Landscape Review Committee
Community Development Center, 231 NE 5th Street
December 21, 2016
12:00 PM

DATE: December 21, 2016
TO: Landscape Review Committee Members
FROM: Chuck Darnell, Associate Planner
SUBJECT: Agenda Item 4B: L 34-16

DATE: December 21, 2016
TO: Landscape Review Committee Members
FROM: Chuck Darnell, Associate Planner
SUBJECT: Agenda Item 3C: L 35-16

DATE: December 21, 2016
TO: Landscape Review Committee Members
FROM: Chuck Darnell, Associate Planner
SUBJECT: Agenda Item 3D: L 36-16

Landscape sketch

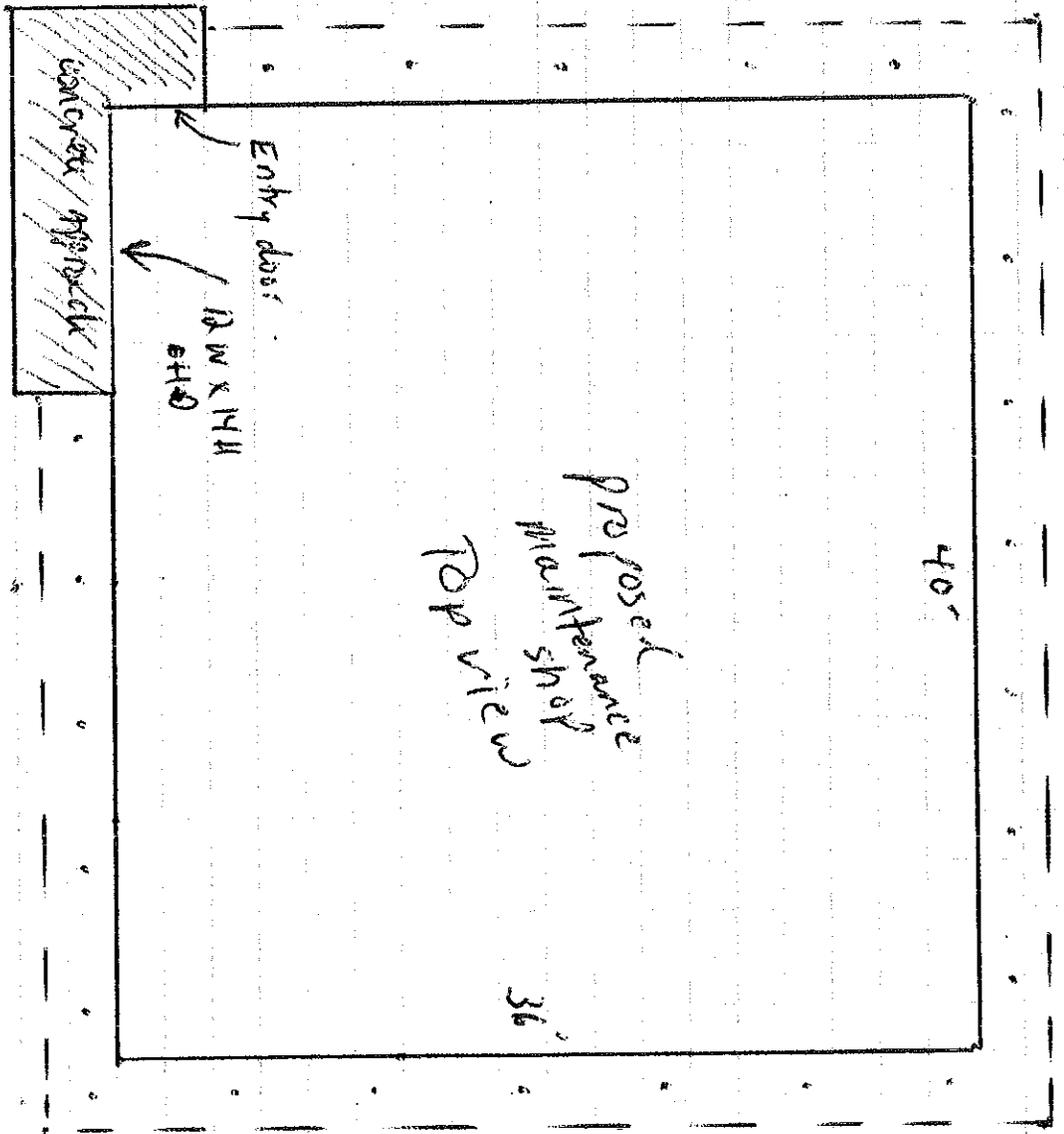
The applicant has proposed to install perimeter plantings around the new building. However, the landscape plan for the overall Hillside site had included much more substantial plantings in the open field

area where the new building is being constructed. Therefore, the Landscape Review Committee has two options. The Committee could approve the landscape plan as submitted to allow the perimeter plantings around the new building, or the Committee could require that the landscaping be installed as it was shown on the landscape plan that was approved in 1999. It is not clear if the original decision was specific to maintaining perimeter landscaping for an overall aesthetic or for screening of the community barn. However, the revised landscape plan meets the code by providing for screening of the proposed use in the form of perimeter plantings around the building. If the applicant is allowed to only install the perimeter landscaping around the new building, staff would suggest that a condition of approval be added that requires the property owner to install further landscaping if and when further development is proposed in the open field area.

1. That the applicant install perimeter landscaping around the new maintenance building as shown on the submitted landscape plan.
2. That in the event that further development is proposed in the open field area north of the new maintenance building, the applicant shall install the landscaping as shown on the landscape plan that was approved in 2009. If the future development is a major change from the previously approved master plan, a new landscape plan for the area north of the new maintenance building shall be submitted to the Landscape Review Committee for approval.
3. That all landscaping approved by the Landscape Review Committee and required as conditions of approval shall be maintained, including necessary watering, weeding, pruning, mowing, and replacement.

Drawing Title:
LANDSCAPE PLAN

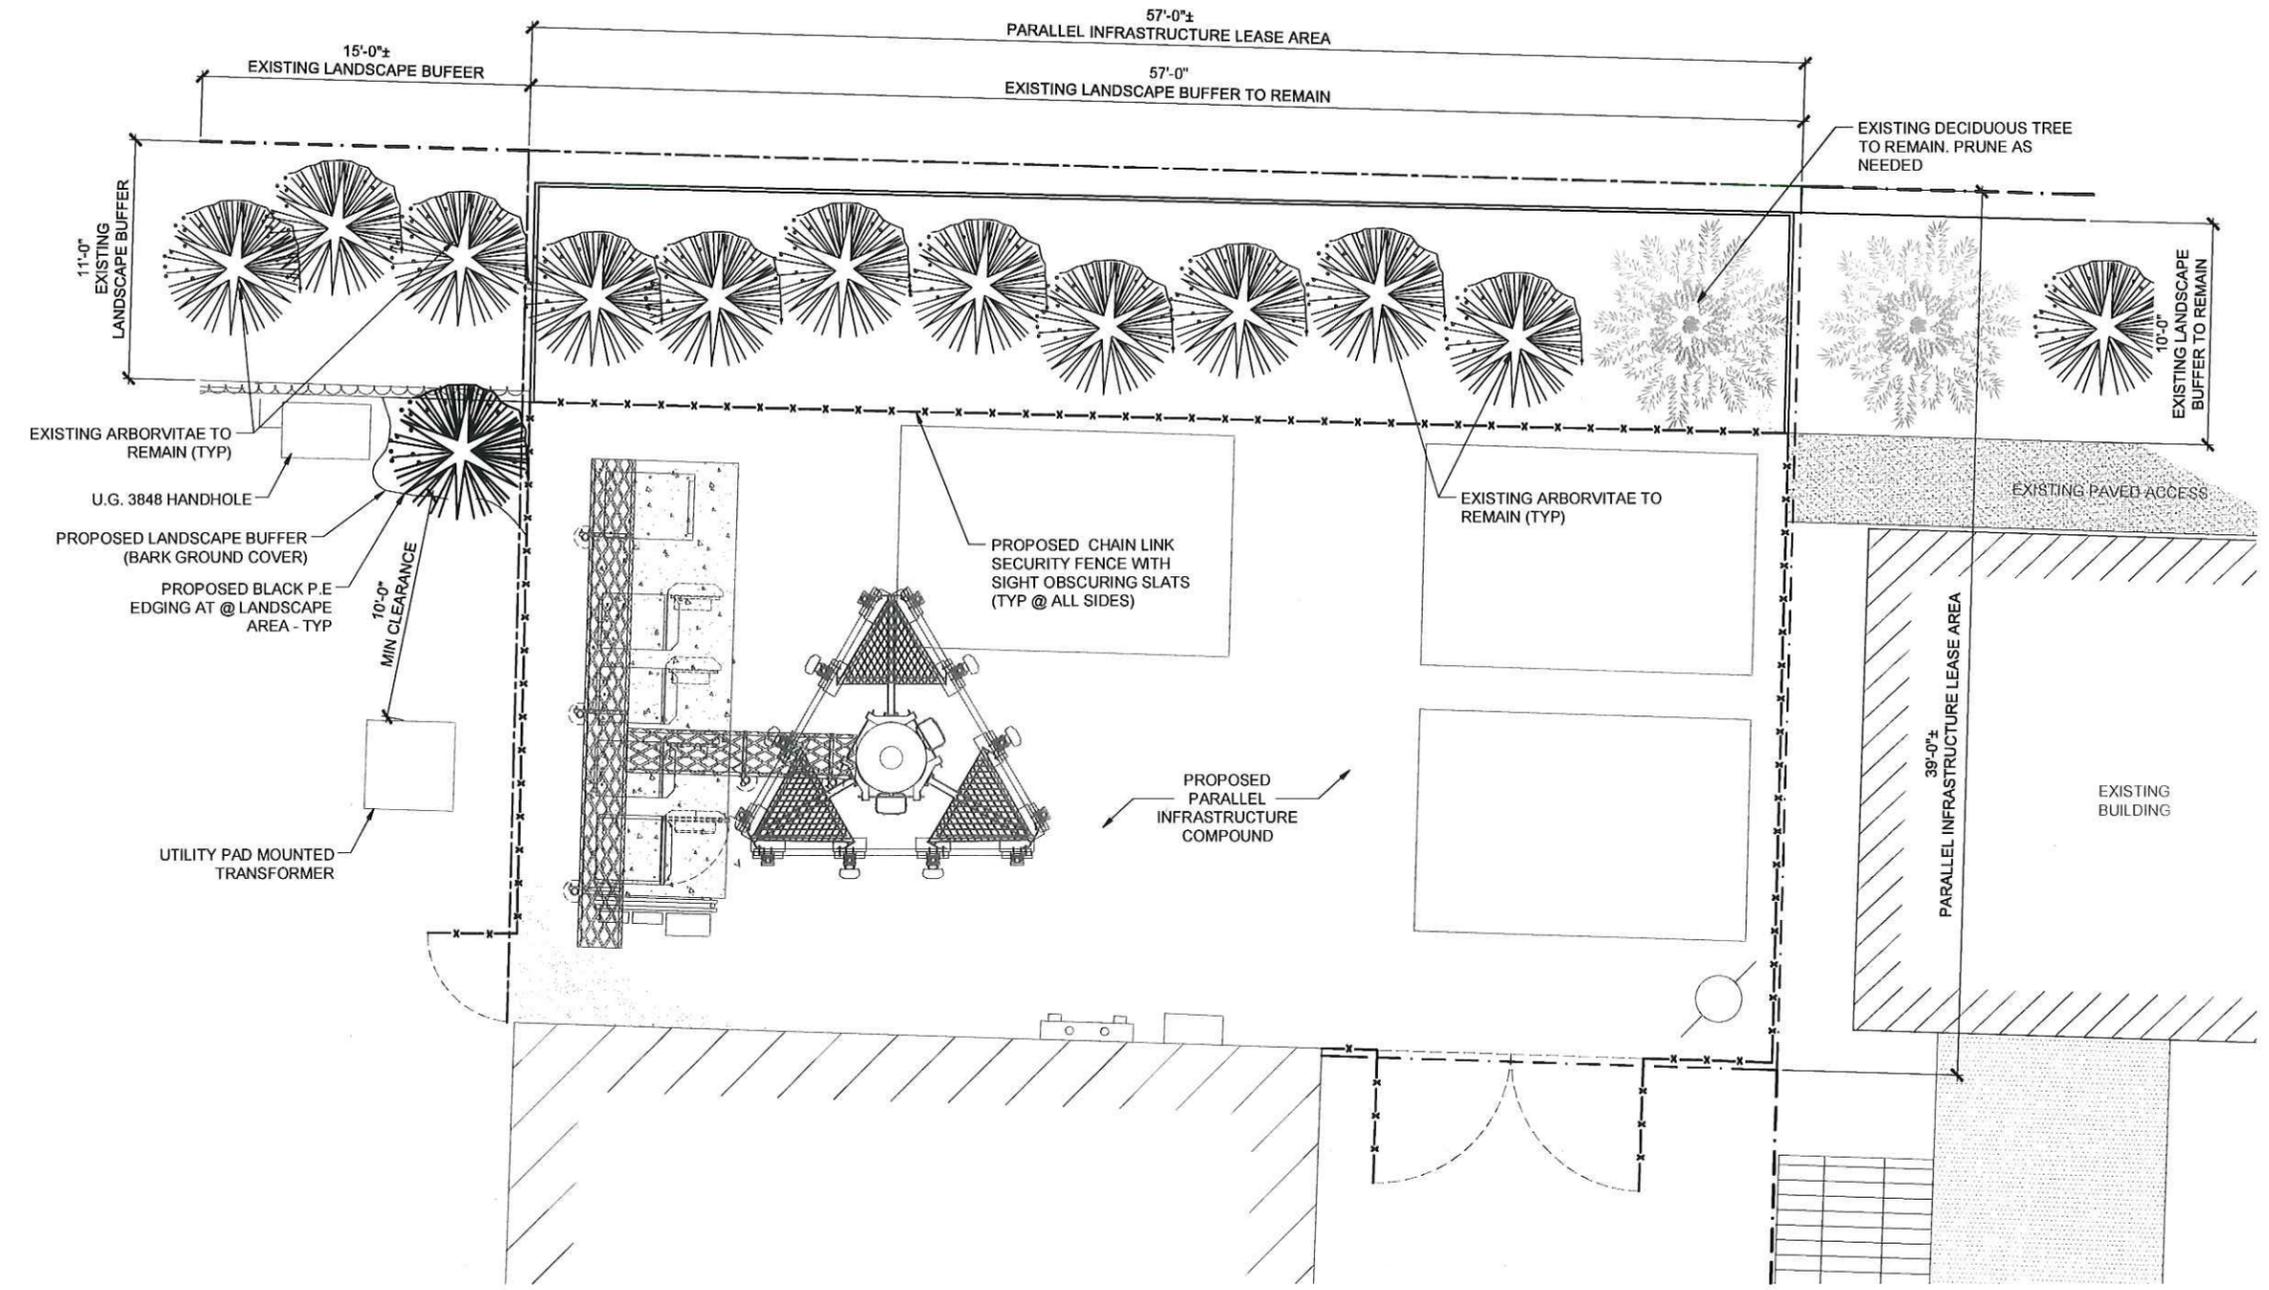
In routing the plans for comments from the various City and agency departments, staff determined that McMinnville Water and Light will only require a 10 foot clearance on the front of the transformer. The other sides only require a 3 foot clearance. The transformer can be placed in such a way that the front of the transformer faces west. Therefore, landscaping could be installed on both the north and south sides of the transformer, up to 3 feet from the side of the transformer. Staff is suggesting that a condition of approval be added to require this additional landscaping.

The east side of the site, while constrained, could accommodate a small amount of landscaping to provide screening of the fence and wireless communications infrastructure. Staff has discussed this with the applicant, and they have suggested that an ivy wall could be added to the east side of the site. This ivy wall would be constructed to be as tall as the fence, and would create the screening effect that the Zoning Ordinance intends for while taking up less physical space. Staff is suggesting that a condition of approval be added to require the ivy wall on the east side of the site.

In total, even with the additional landscaped areas as described above, the applicant is not providing the amount of landscaping that would normally be required if the 10 foot landscaped buffer was installed as required by Section 17.55.050 (B) of the McMinnville Zoning Ordinance. Section 17.55.050 (B) allows for the Planning Director to require "the addition of a proportional landscape area that will enhance the

If a 10 foot landscaped buffer was installed around the entire wireless communications tower site (which is 57 feet wide and 35 feet long) a total of 2,240 square feet of landscaped area would have been provided. As shown in the applicant’s proposed plan, and including the additional landscaped area that will be required as conditions of approval, the applicant is providing 995 square feet of landscaped area. Therefore, Section 17.55.050 (B) allows for the Planning Director to require 1,245 square feet, the difference in what is normally required and what is being provided, of additional portions of the site to be landscaped to provide the “proportional landscape area”. Staff is suggesting that a condition of approval be added to require the additional 1,245 square feet of landscaped area to be provided elsewhere on the overall property.

1. That the applicant install a vine or ivy wall along the east side of the fence that is being installed around the site of the wireless communications tower. The ivy wall shall be constructed to be at least seven (7) feet tall and shall be installed to provide screening of the wireless communications tower from adjacent uses.

4. That the applicant install a 1,245 square foot proportional landscaped area in another location on the Yamhill County Fairgrounds site that will enhance the subject site either at a building perimeter, parking lot, or street frontage. The applicant shall submit a landscape plan for this proportional landscaped area, which will be approved by the Planning Director.
